Technical Service Bulletin

01 MY16/17 2.0TFSI, MIL on, DTC P001600

01 17 00 2046377/1 February 13, 2017.

Model(s)	Year	VIN Range	Vehicle-Specific Equipment
A5, A5 cabriolet, Q5	2016 - 2017	All	2.0TFSI
Q3	2017	All	2.0TFSI

Figure 1. Worn thrust surface.

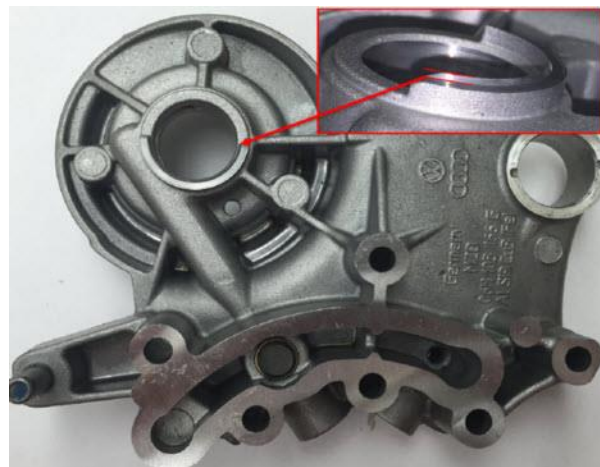
On some MY 2016 and 2017 vehicles equipped with 2.0TFSI engines, engine codes (CPMB, CAED or CCTA), DTC P001600 can be set due to a worn intake side - camshaft bearing bridge thrust surface (Figure 1).

Improved camshaft bearing bridge with 50% larger thrust surface in production starting 02/10/2017.

1. Measure the intake camshaft end play.
2. If intake camshaft endplay is *less than* 0.2mm this TSB **does not** apply, proceed with GFF to diagnose root cause.
3. If intake camshaft end play is *greater than* 0.2mm, proceed to step 4.
4. Replace the camshaft bearing bridge (Figure 2) with part number 06H 103 144 K (Figure 3, improved part).
